SEWAGE DISPOSAL SYSTEM

DEPARTMENT OF HEALTH AND MENTAL HYGIENE

SUBDIVISION Jocelyn Acres LOT 2 ROAD 6656 Luster Drive

PLAT SHOWING FIELD LOCATION
OF PROPOSED WELL
LOT 2
SECTION FOUR LOTS 1 & 2
JOCELYN ACRES
5TH ELEC. DIST. HOWARD CO. MD
SCALE 1" = 100' DATE 4/27 ' 7
PLAT # 5584

SCALE DRAWING OF HOLES 1" = 50'

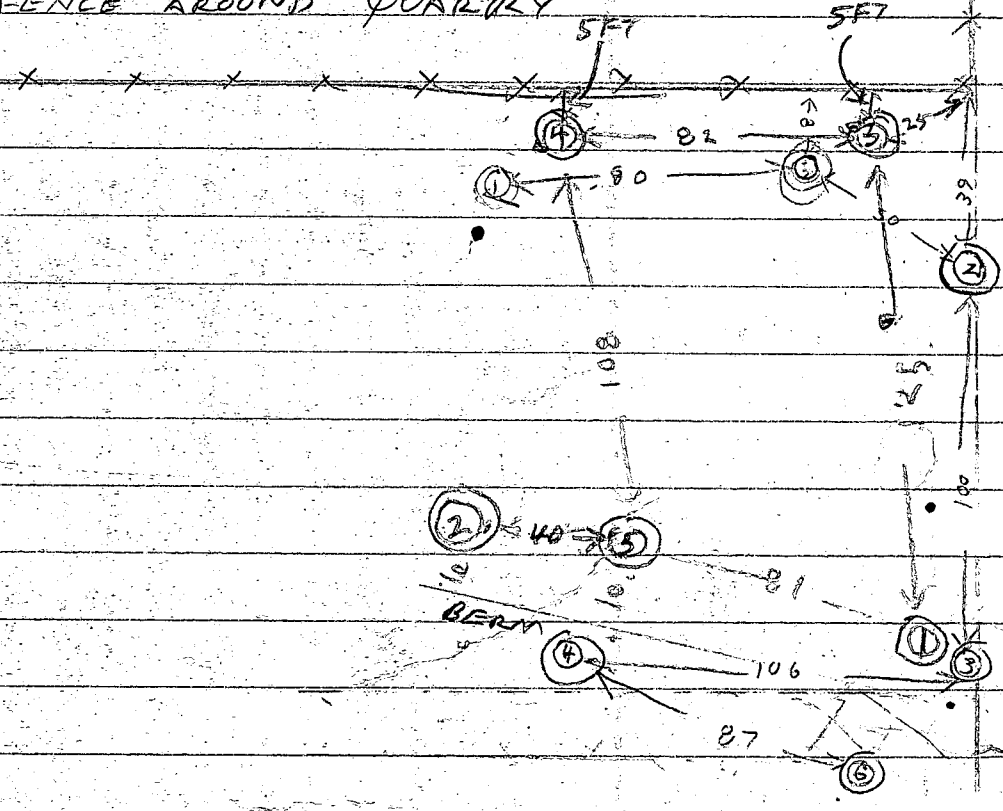
HOLES 3 4 6 DO NOT SCALE OFF PROPERLY IN RELATION TO BERM

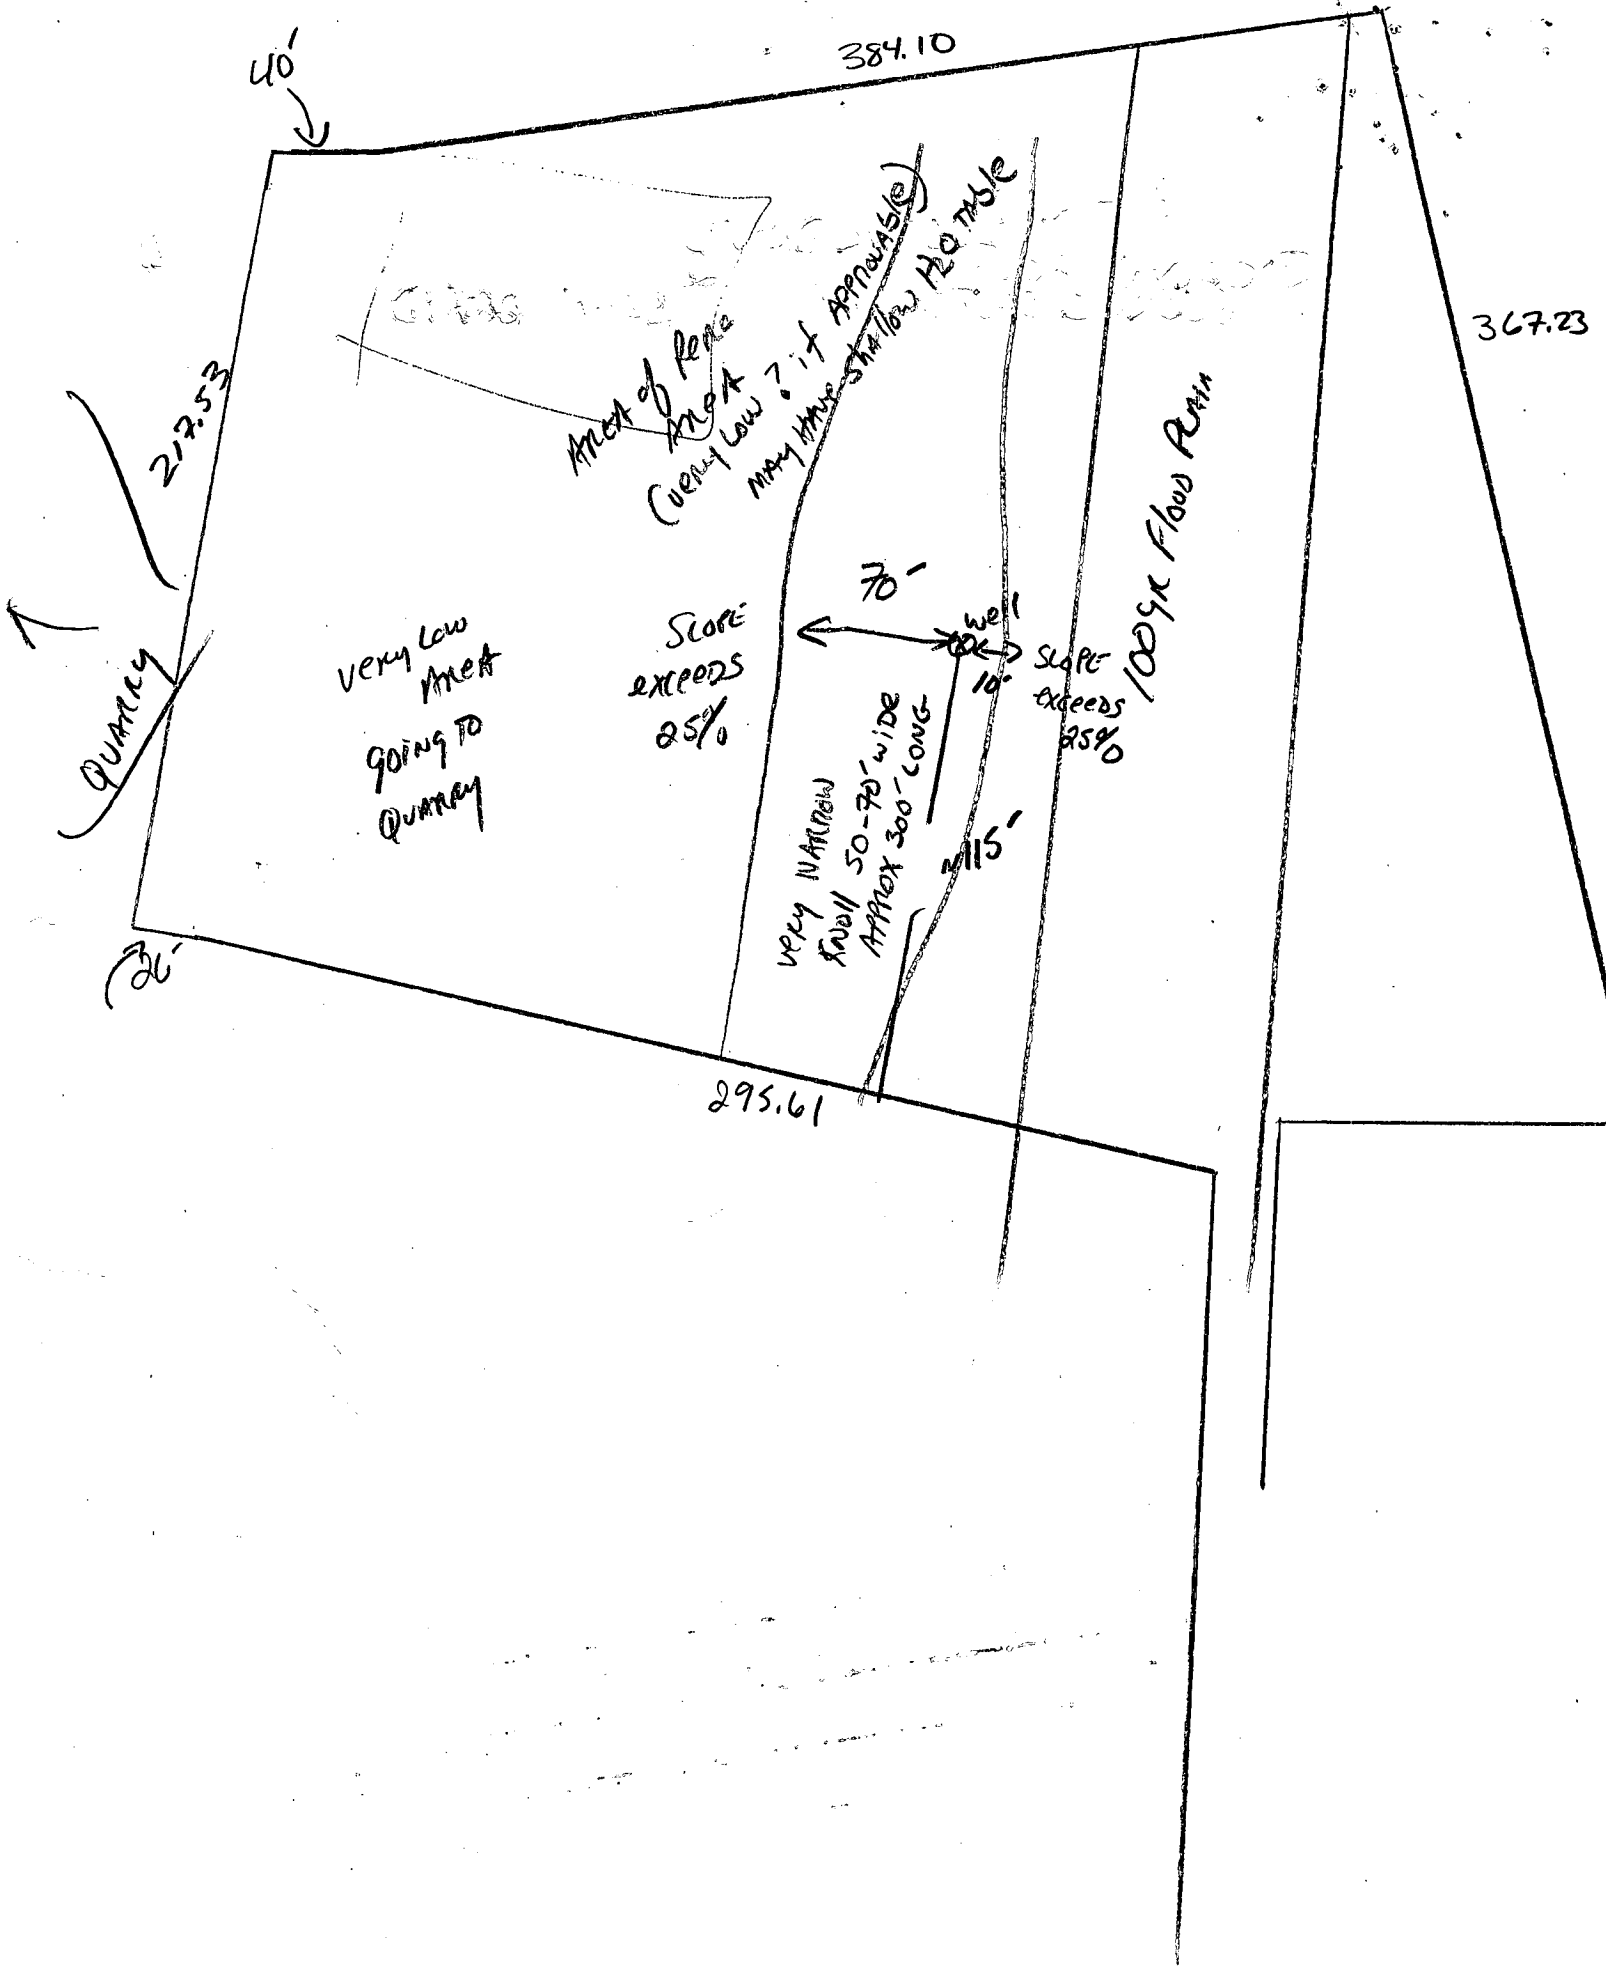
VERY LOW AREA
GOING TO
QUARRY

Area of Pond
Area
(Very Low?) if Approx 100'
MAY HAVE SHALLOW HEAD TABLE

VERY NARROW
TUNNEL 50-70' WIDE
APPROX 300' LONG

WELL
10'
SLOPE
EXCEEDS
25%

HOUSE LOCATION: LOT 2 SECT. 4 "JOCELYN ACRES"

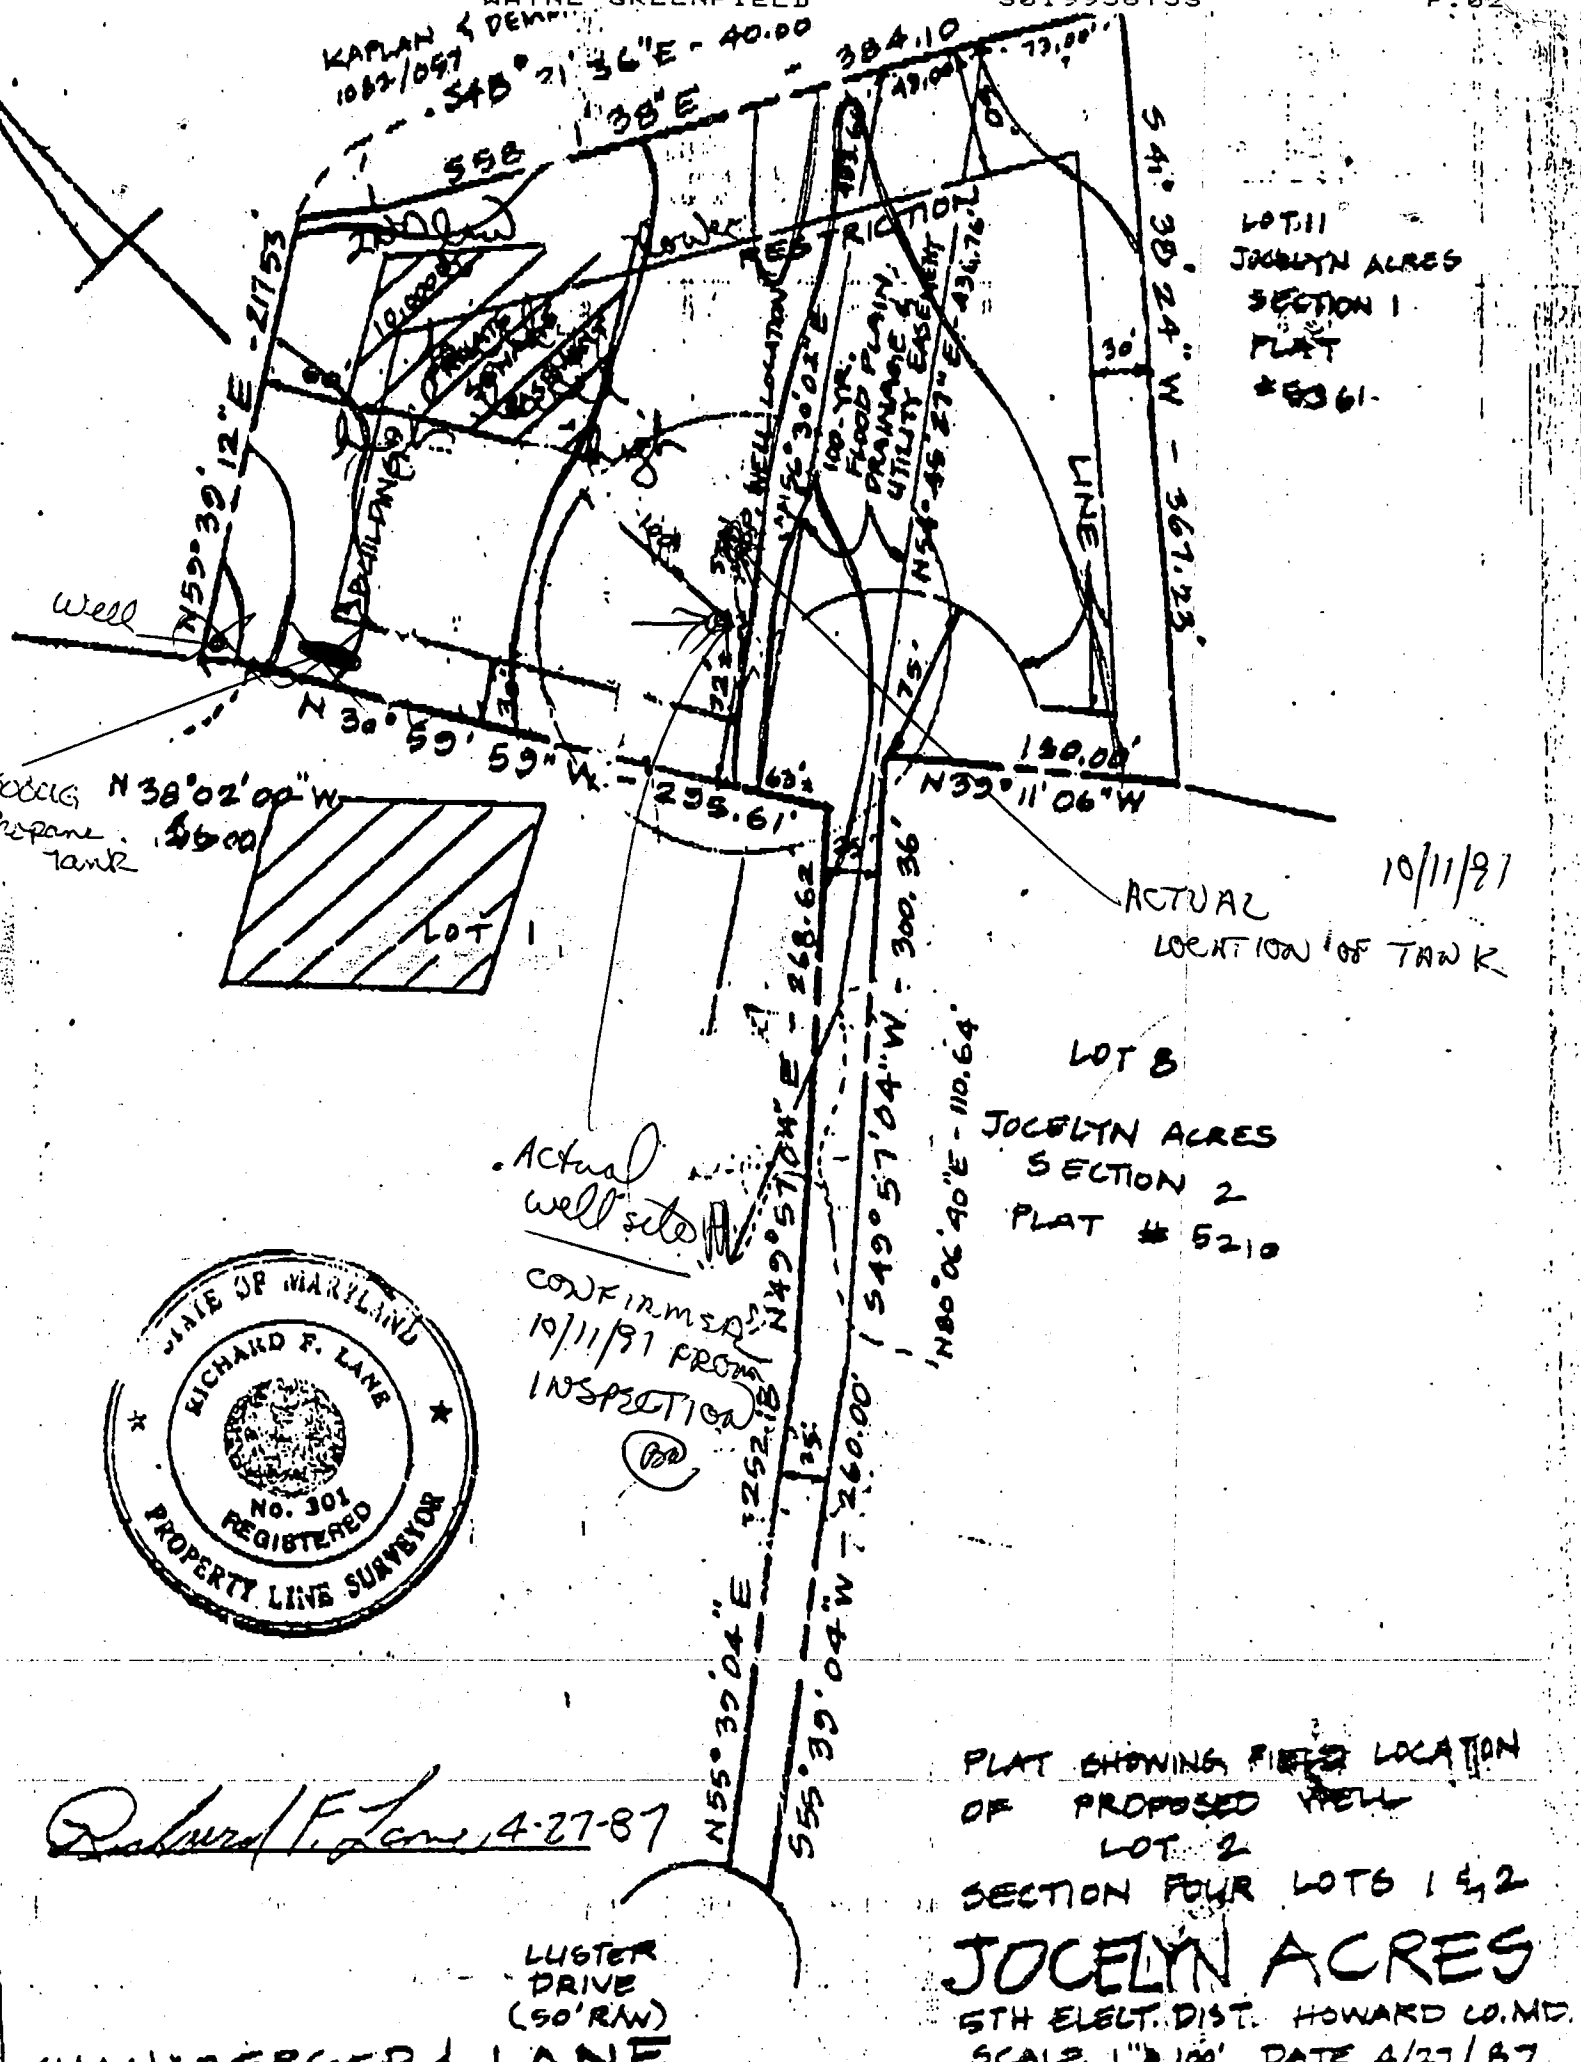
4/18/94
Proposed pool
location has no
impact to existing
well or septic
Amy McMillan

PLAT SHOWING FIELD LOCATION
OF PROPOSED WELL

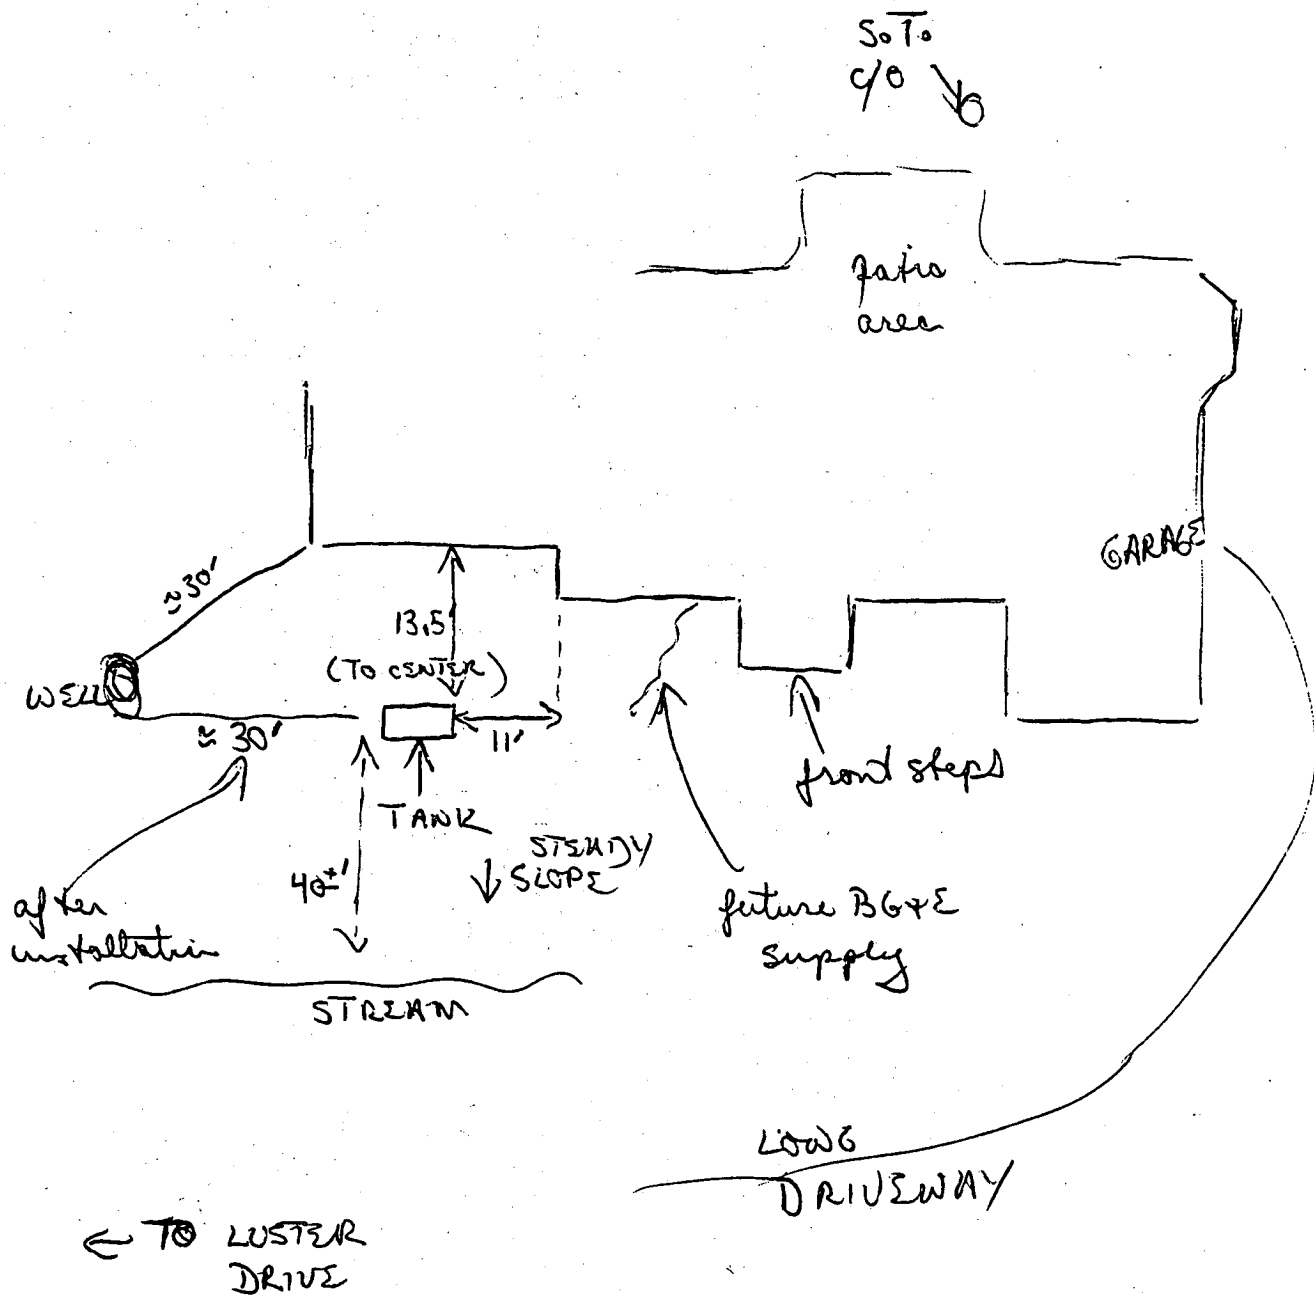
10/11/91
ACTUAL
LOCATION OF TANK

Actual
well site
CONFIRMED
10/11/91 FROM
INSPECTION

planned tank location would have been $< 10'$ from well casing. owner agreed to shift location further from the well to site referenced above. This site is more acceptable. OK to process permit.
